FERGUSON TOWNSHIP PLANNING COMMISSION
Regular Meeting Agenda
Monday, April 25, 2022, 6:00 PM

2. 2026 Sandy Drive—Centre Volunteers in Medicine Preliminary Land Development Plan

**CENTRE VOLUNTEERS
IN MEDICINE AT
2026 SANDY DRIVE**

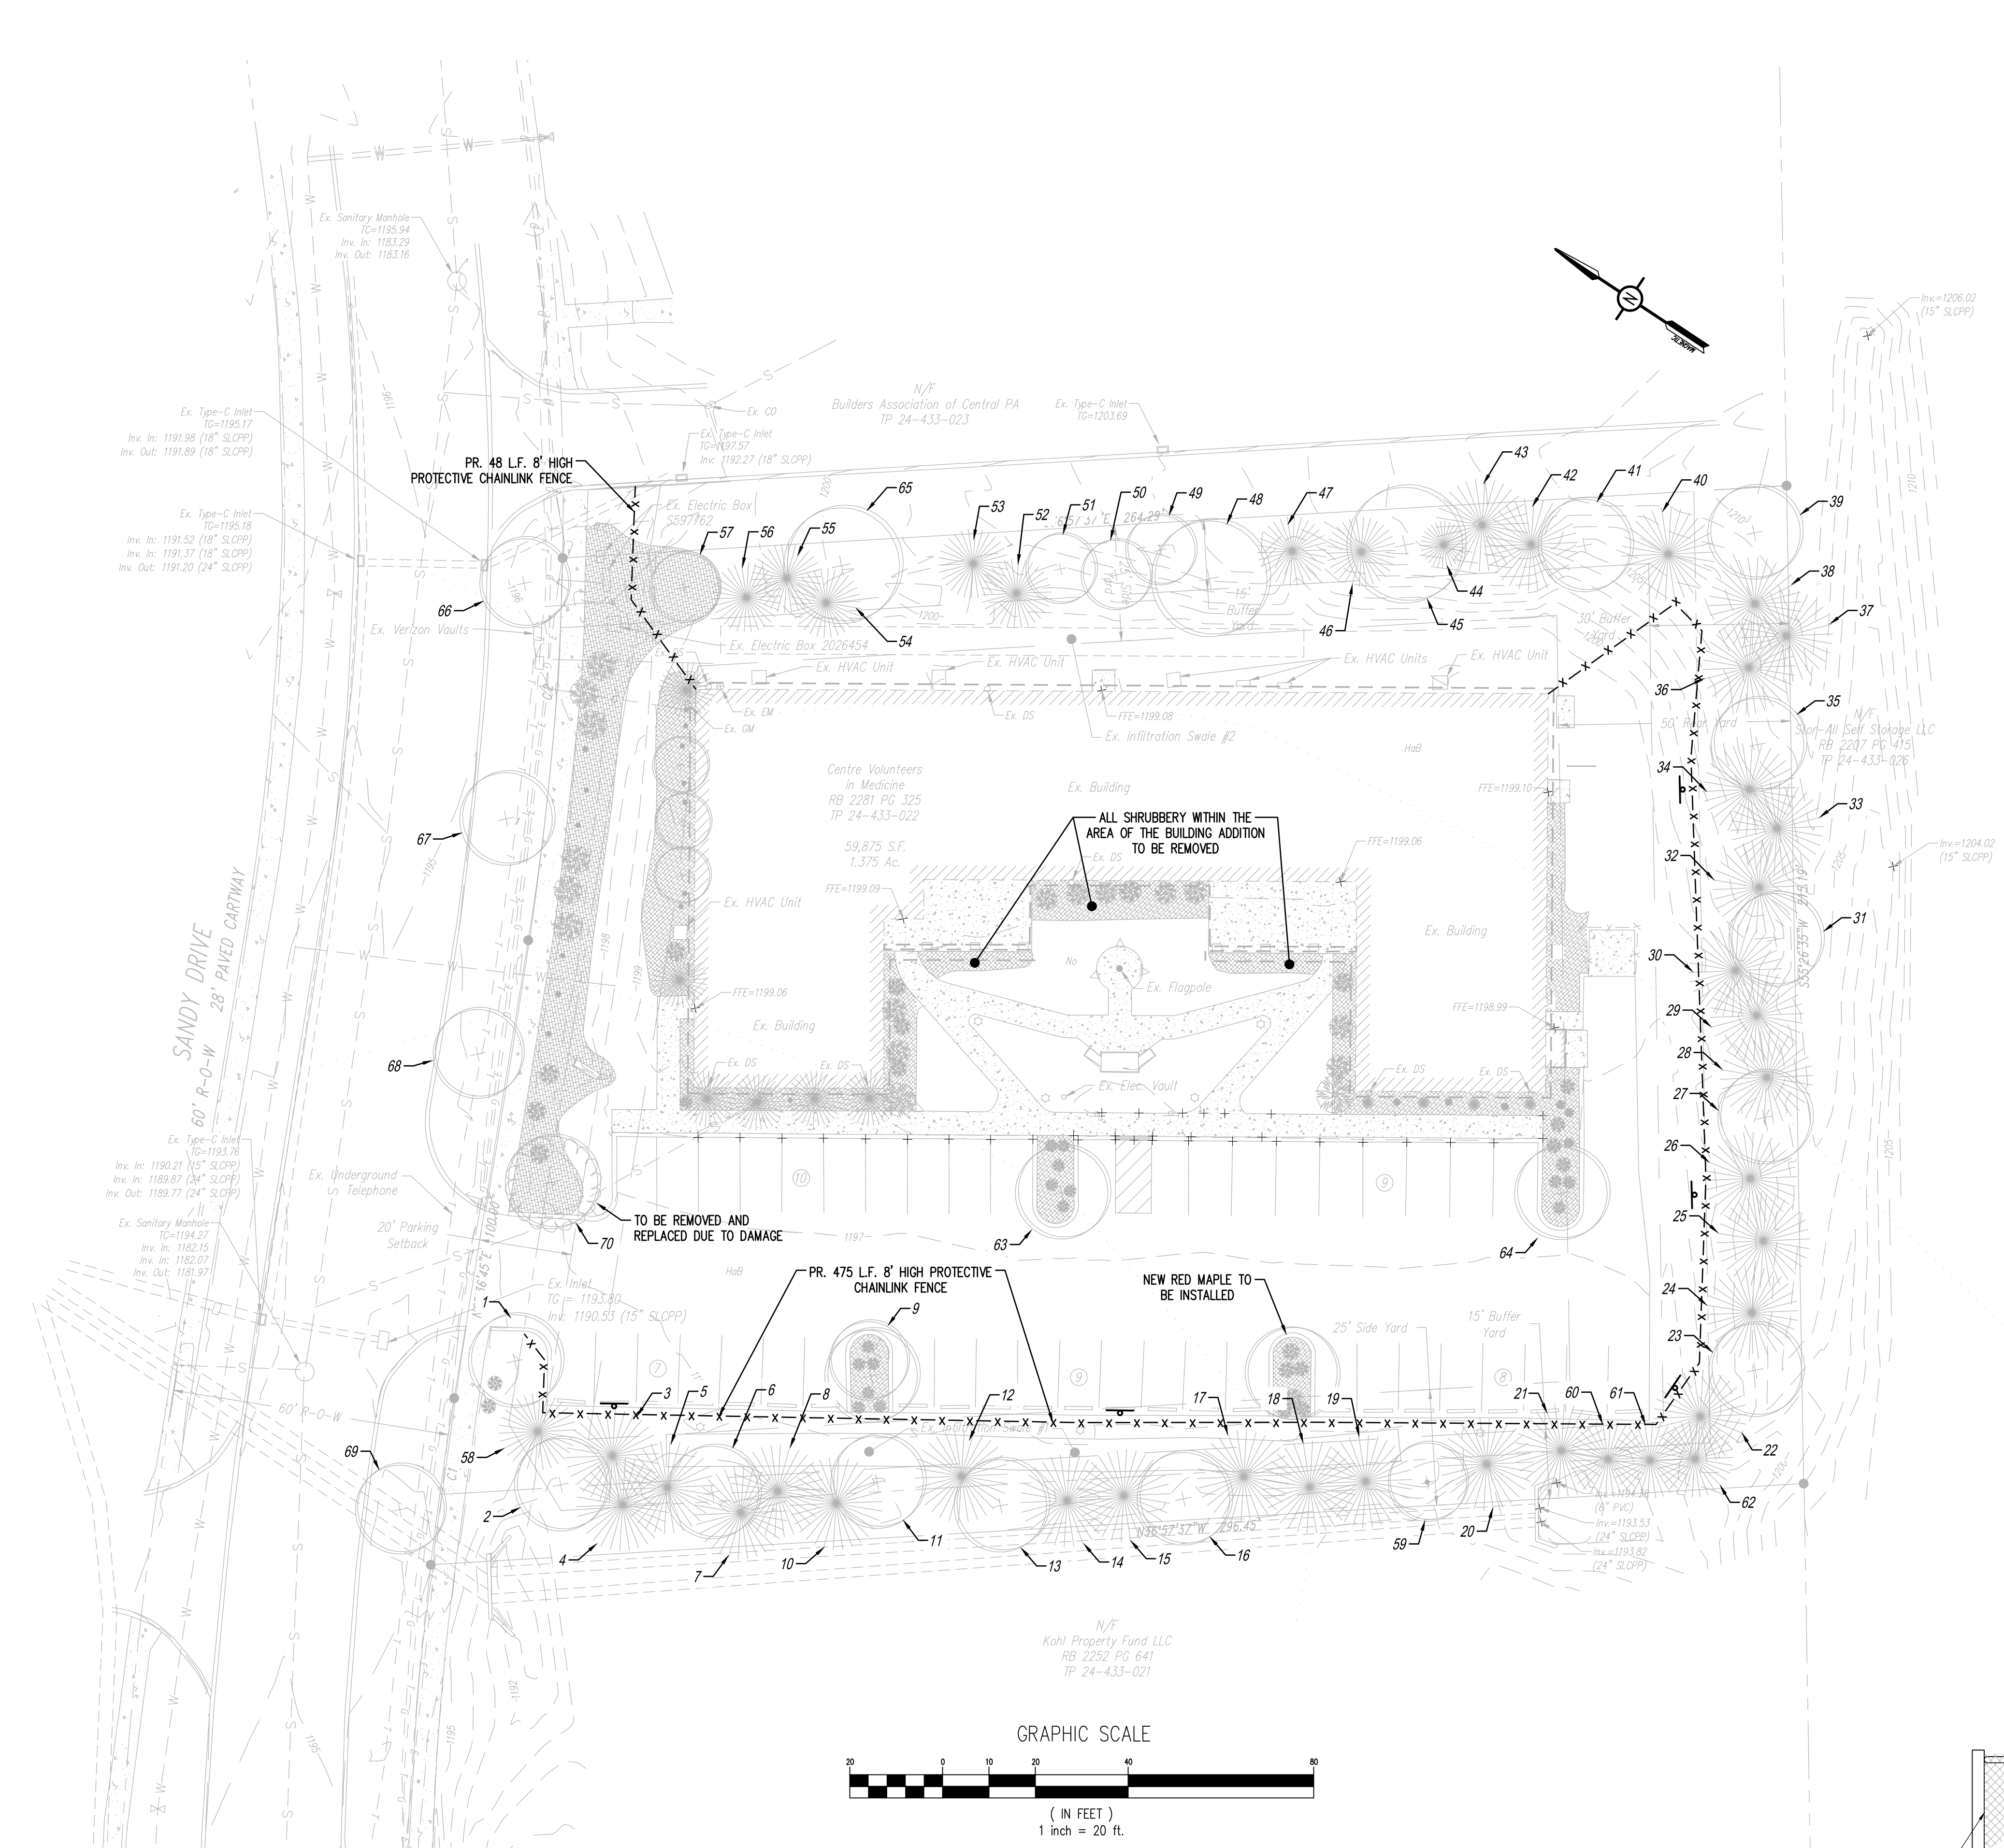
7. The landscaping plan must graphically depict the location of all buffer yards and planting areas. (Chapter 27, Section 401.C.1.g).
Sheet 7 depicts all Planting Areas, Trees and shrubs existing and to be preserved as well as the new Landscaping beds (mulch) along building and sidewalk. The 15' BUFFERS are labeled and made black & italicized to standout.

8. The landscaping plan must graphically depict the distribution, mature height and spread of all required plant materials. The Official Township plant list shows the plant height and spread which is to be used for each plant species (Chapter 27, Section 707.5.B). ***Sheet 6 identifies all of the preserved trees. A single new tree and the current damaged tree #70 as described before, 6" caliper is to be planted as listed throughout and specifically on Sheet 7 the Landscape Plan.***

9. The landscaping plan must show a table, which identifies the required and proposed number of each plant species being provided for each type of buffer, screen or other use. (I.e. –the number of plants within each flexible buffer yard). The table shall also identify the scientific and common name of each plant, the mature height and spread, and the symbol used for the plant (Chapter 27, Section 707.5.C).
A single new tree and the current damaged tree #70 as described before, 6" caliper is to be planted as listed throughout and specifically on Sheet 7 the Landscape Plan. A TABLE has been added, now.

PROJECT NO.	21189
DATE	NOVEMBER 11, 2021
SCALE	1" = 20'
SHEET NO.	8

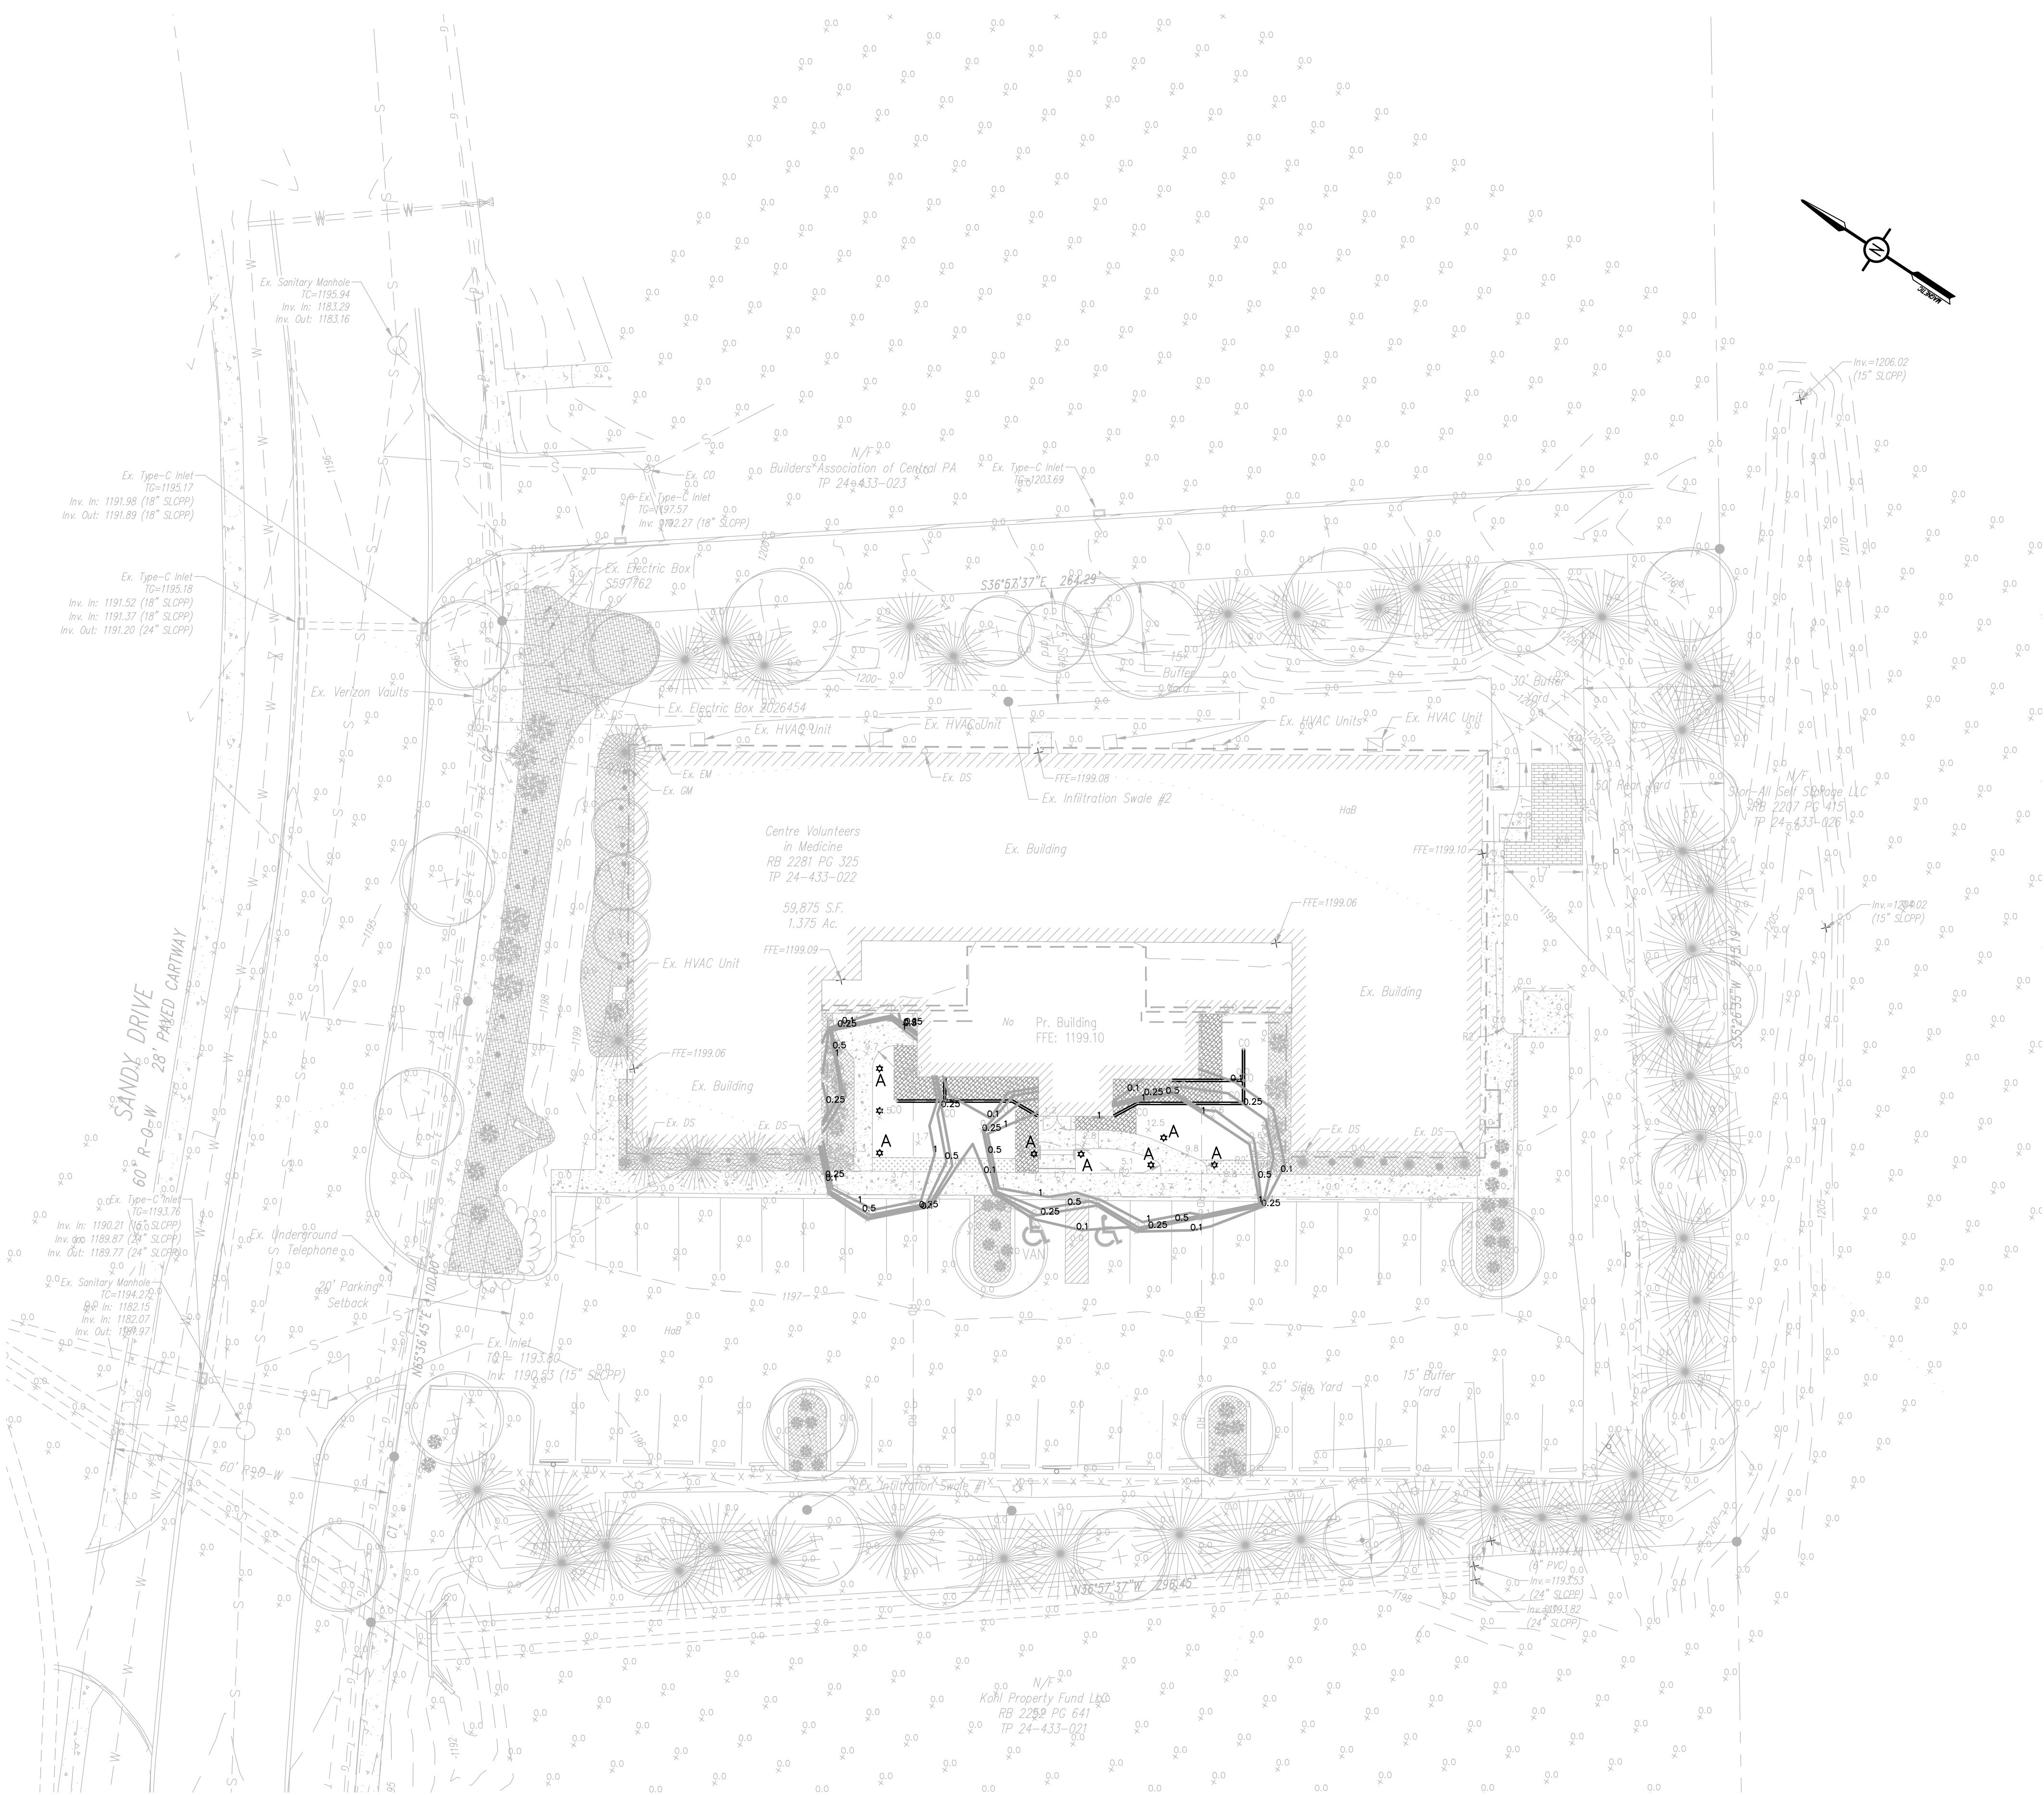
4. The plan must be signed, all fees paid to the Township, and the plan recorded within the plan deadline.
Acknowledged.
5. The intensity of all outdoor light fixtures must be included on the plan. (Chapter 22, Section 401.C.1.f)
Refer to Sheet 8 LIGHTING PLAN.

6. The light pattern produced by all outdoor light fixtures must be included on the plan. (Chapter 22, Section 401.C.1.f)
Refer to Sheet 8 LIGHTING PLAN.
